Access Compliance Report Public Rights-of-Way (Curb Ramps)

Main Street: GERSHON_PL Cross Street: 17TH_ST Location: NE

ADA ID: RPRK220125123057 Ramp Type: Type 4 - Parallel Initial Pass/Fail: Fail Overall Compliance: No Severity Score: 2

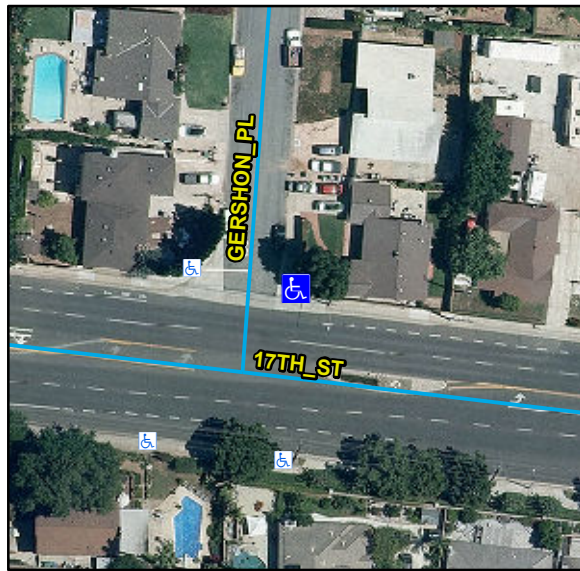
Compliance	Description	Data	Compliance	Description	Data
N/A	Ramp Length LT (in)	96	N/A	Ramp Length RT (in)	83
Yes	Ramp Width LT (in)	90	Yes	Ramp Width RT (in)	90
Yes	Ramp Run Slope LT (%)	4.6	Yes	Ramp Run Slope RT (%)	4.5
Yes	Ramp Cross Slope LT (%)	0.9	No	Ramp Cross Slope RT (%)	3.9
N/A	Landing Present	N/A	N/A	DWS Provided	N/A
N/A	Landing Length (in)	N/A	N/A	DWS Contrast	N/A
N/A	Landing Width (in)	N/A	N/A	DWS Length (in)	N/A
N/A	Landing Run Slope (%)	N/A	N/A	DWS Full Width	N/A
N/A	Landing Cross Slope (%)	N/A		DWS Offset Type	N/A
N/A	Landing Movement Obstructed?	N/A	N/A	DWS Offset Left (in)	N/A
	Landing Movement Type	N/A	N/A	DWS Offset Right (in)	N/A
N/A	Landing Shared	N/A			
N/A	Clear Space	Yes			
N/A	Clear Space To Crosswalk (in)	N/A			
N/A	Marked Crosswalk 1	No	N/A	Marked Crosswalk 2	No
	Crossing 1 Direction	NW		Crossing 2 Direction	SW
	Marked Crosswalk 1 Width (in)	N/A		Marked Crosswalk 2 Width (in)	N/A

Remove & Replace Curb Ramp With Two New Directional Ramps or Equivalent.
